## **Amendments to the Drawings:**

Appln. No. 10/753,246
312 Amdt. Dated April 5, 2006
Reply to Notice of Allowance dated February 28, 2006
Annotated Sheet Showing Changes

FIG. 2

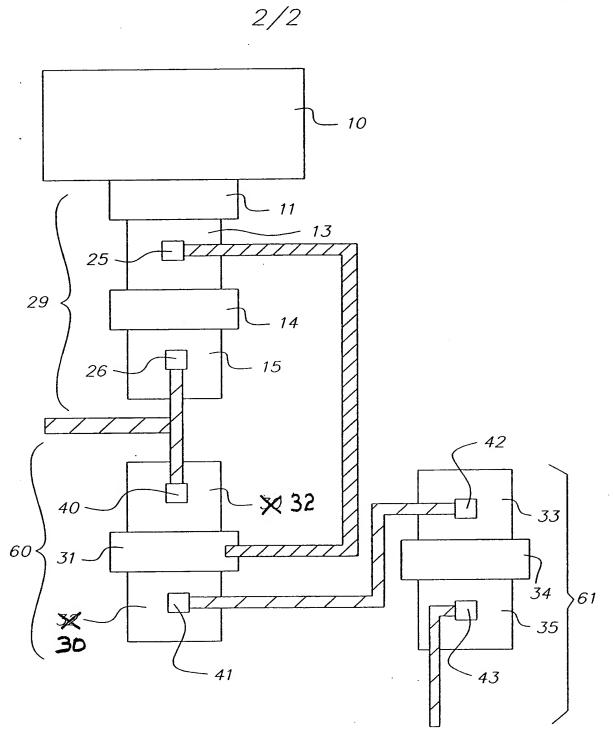
The attached sheet of drawings includes changes to Figure 2 (Fig.

2). This sheet replaces the original Figure 2. The drawing inadvertantly transposed the position of the source and drain of the source follower. Approval by the Examiner is respectfully requested.

The amendment to the specification is made to correspond to the transposition of the reference numerals in Fig. 2 as discussed hereinabove.
